STAFF RECOMMENDATION 918 Fatherland Street September 16, 2015

Application: Demolition; New construction—infill
District: Edgefield Historic Preservation Zoning Overlay
Council District: 06
Map and Parcel Number: 08216026800
Applicant: Twin Team Construction, LLC
Project Lead: Sean Alexander, sean.alexander@nashville.gov

Application is to demolish a non-contributing building and construct a new two-family dwelling.

FRONT ELEVATION
SCALE: 1/4"=1'-0"

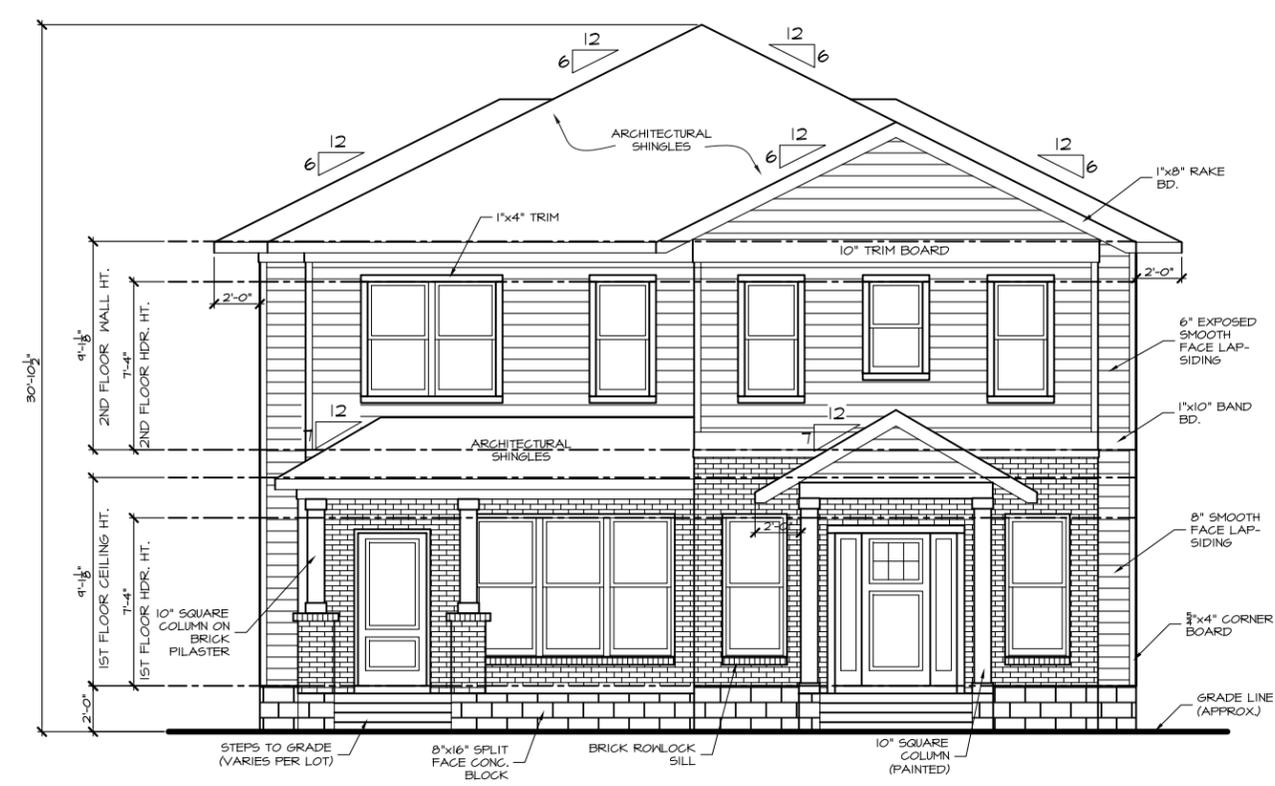
The duplex is oriented to face Fatherland Street. The duplex units will have two separate entrances, the left entrance set back eight feet (8') from the right entrance. Both units will have an eight foot (8') deep front porch. Historic houses in the surrounding area typically have concrete walkways leading from the front sidewalk to the front entries, but no walkways are shown in the proposed plans. With the addition of front walkways, Staff finds that that duplex's orientation meets Section III.B.2.e of the *Edgefield Historic Preservation Zoning Overlay: Handbook and Design Guidelines*.

The duplex will be primarily clad with cement-fiberboard siding, with brick on the first story of the front section. The clapboard siding is shown as having an eight inch (8") exposure on the first story and a six inch (6") exposure on the second. In the past the Commission has approved clapboard siding with a reveal greater than five inches (5")

RIGHT ELEVATION
SCALE: 1/4"=1'-0"

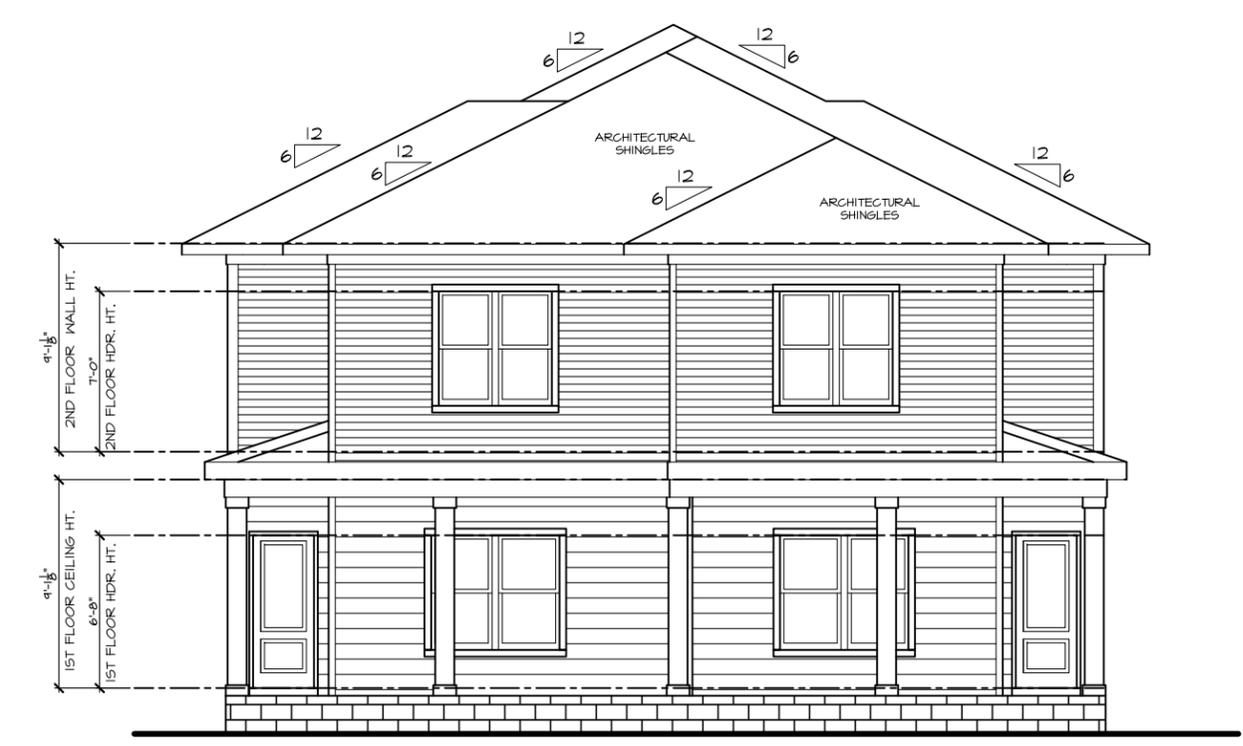
The infill's windows will generally be twice as tall as they are wide, and the windows on the second story are not taller than those on the first story. This is consistent with the proportion of window openings on historic buildings. The front and side elevations will be generally well covered with evenly spaced doors and windows, with the exception of one area on each side in the center section of the building. Paired windows have four to six inch (4"-6") mullions between them. Typically, front and side elevations do not have expanses of walls greater than ten to twelve feet (10'-12') without an opening. With the condition that a window is added on each side, Staff finds that that infill's proportion and rhythm of openings meet Section III.B.2.f. of the *Edgefield Historic Preservation Zoning Overlay: Handbook and Design Guidelines*.

1. Walkways are added to connect the front porches to the sidewalk;
2. The finished floor height shall be consistent with the finished floor heights of the adjacent historic houses, to be verified by MHZC staff in the field;
3. An additional window is added on the first story on the right and left side;
4. Staff approve a brick sample, the asphalt shingle color, that the primary siding exposure be five inches (5”), and that staff approves of the materials of the porch floors, stairs, windows, and doors; and
5. The HVAC shall be located behind the house or on either side, beyond the mid-point of the house;
6. Staff approve all appurtenances, including but not limited to, fencing, walkways, exterior lighting fixtures, and parking pads.
